Well Name: EAGLE 34 FEDERAL	Well Location: T17S / R27E / SEC 34 / SESW /	County or Parish/State: EDDY / NM
Well Number: 34	Type of Well: OIL WELL	Allottee or Tribe Name:
Lease Number: NMLC067849	Unit or CA Name:	Unit or CA Number:
US Well Number: 300153284000S1	Well Status: Producing Oil Well	Operator: REDWOOD OPERATING LLC

Notice of Intent

Type of Action Plug and Abandonment

PLUG AND ABANDONMENT CONDITIONS OF APPROVAL

Redwood	PROPOSED	
Author:	Abby @ BCM	
Well Name	Eagle 34 Fed	Well No. #34Q
Field/Pool	Red Lake; Gironeta- Yeso	API #: 30-015-32840
County	Eddy	Location: Sec 34, T17S, R27E
State	New Mexico	990 FSL & 2310 FWL
Spud Date	7/14/2003	GL: 3588

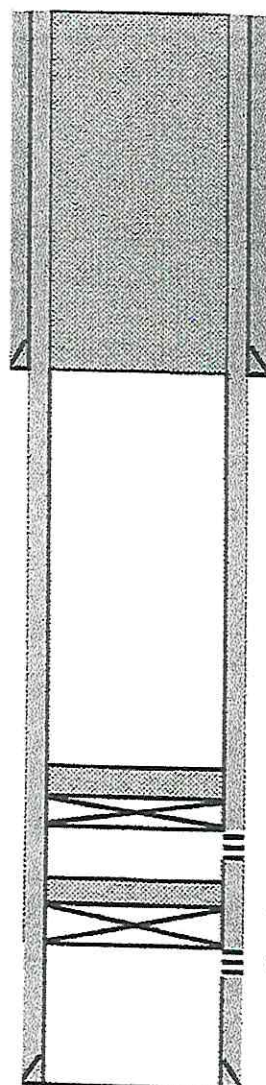
1. Set 5 1/2" CIBP @ 2942'. ~~Dump bail 35' or~~ spot 25 sx cmt @ 2942-2742'. *wcc & TPK*
2. Set 5 1/2" CIBP @ 1850'. Circ hole w/ MLF. Pressure test csg. Spot 25 sx cmt @ 1850-1650'.
3. Spot 55 sx cmt @ 506' to surface. (8 5/8" Shoe)
4. Cut off well head, verify cmt to surface, weld on Dry Hole Marker.

1. Set 5 1/2" GIBP @ 2942'. ~~Dump bail 25'~~ or spot 25 sx cmf @ 2942-2742'. WOC {TAG
Perfs @ 2992-3201

→ WOC & Tag
